Service Manual

SA-AK230PL

Top Cabinet change (Additional Information)

Please file and use this supplement manual together with the service manual for Model No. [SA-AK230PL--S, Order No. MD0411548C3].

2.1. Cabinet Parts Location (Additional Information)

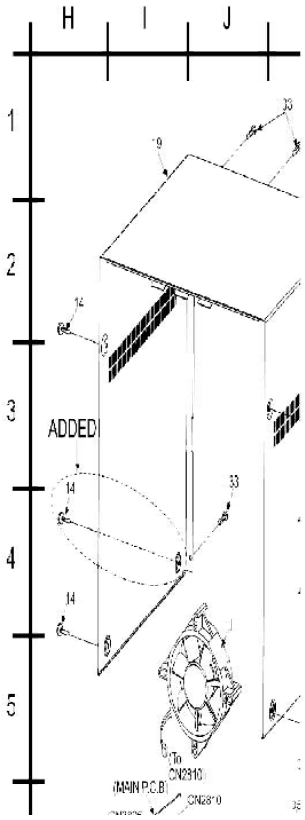
During the replacement of the top cabinet for the mentioned models, the below rules of compatibility (Table 1) must be followed & parts must be replaced correctly. This is mainly due to top cabinet specification change (additional of one screw hole) for improvements.

With reference to page 94 (section 22.3.1) of the original service manual for SA-AK230PL-S. The cabinet parts location below is for the new implementation.

- When replacing the new top cabinet, ensure that the NEW bottom

chassis must also be changed together at the same time (Refer to Table 1).

Ref. No.	Part No.	Part Name & Description	Remarks
		CABINET AND CHASSIS	
19	RKMX0105-S1	TOP CABINET	[M]
22	RMKX0099-2	BOTTOM CHASSIS	[M]
